3. APPLICATION FOR NEW CONSTRUCTION AT 667 BANK STREET, A PROPERTY DESIGNATED UNDER PART V OF THE *ONTARIO HERITAGE ACT* AND LOCATED IN THE CLEMOW ESTATE EAST HERITAGE CONSERVATION DISTRICT
- DEMANDE DE NOUVELLE CONSTRUCTION AU 667, RUE BANK, UNE PROPRIÉTÉ DÉSIGNÉE EN VERTU DE LA PARTIE V DE LA *LOI SUR LE PATRIMOINE DE L'ONTARIO* ET SITUÉE DANS LE DISTRICT DE CONSERVATION DU PATRIMOINE DU DOMAINE CLEMOW EST

**Built Heritage Sub-Committee / Sous-comité du patrimoine bâti
November 10, 2017 / 10 novembre 2017**

SUBJECT: Application for New Construction at 667 Bank Street, a property designated under Part V of the *Ontario Heritage Act* and located in the Clemow Estate East Heritage Conservation District

Document 5 – Proposal

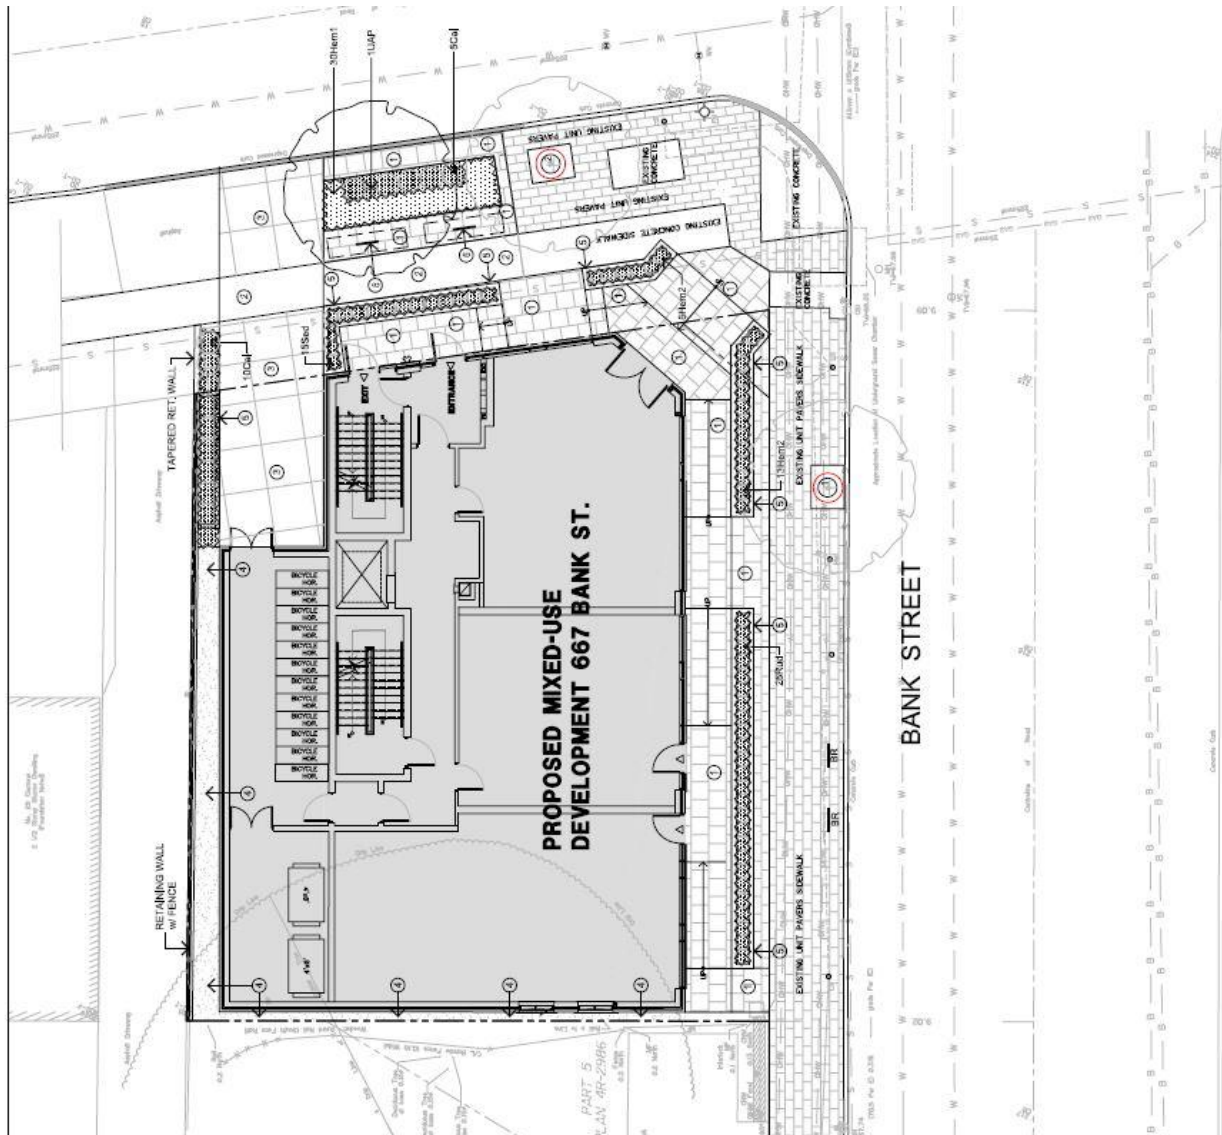
We had expressed concerns about previous versions of this proposal, including that the façade facing the adjacent house in the Heritage Conservation District was too high and too close. The current version has addressed this by eliminating units that were close to the rear lot line, so that there is now only a one-storey structure at the rear. The impact of this is also mitigated by having a green roof.

As we noted previously, the revisions made to the north façade are an improvement and more compatible with the park than the initial application. Although we had previously commented that the cornice line should be at the third rather than fourth levels, to be more compatible with the historical pattern of the streetscape, we do not consider this a very major issue.

Thank you for the opportunity to comment on this proposal. The GCA welcomes the potential development of this long vacant site however, even with the changes made to the proposal, we continue to have concerns about its compatibility with the Clemow Estate East District and do not feel it meets the infill principles outlined in the District Guidelines.

While we acknowledge attempts were made to better the transition between the height of the proposed development and its neighbour to the East. The 5th storey "stepback" included in the design is by no means sufficient and continues to make the buildings impact greater as designed. Further to this, the building height is not in keeping with its neighbours and the character of the street. No other commercial building on Bank Street in the Glebe save those in the Landsdowne development block are more than four stories. A reduction in height of this building to four stories with a step back on the East elevation to two or three stories, before the final transition to one at the neighbouring house would allow for a more appropriate transition to the neighbouring residential buildings and would be in keeping with the spirit of the Heritage District Guidelines.

Lastly, we would like to note that we appreciate the updates to the northern wall of the building to speak better to the park, which is a defining feature of the district, the proximity of the building the park continues to be a concern and further should be done to transition.

North rendering, current version, showing removal of two storeys at east side

South rendering, current version, showing removal of two storeys at east side and new attached accessory building
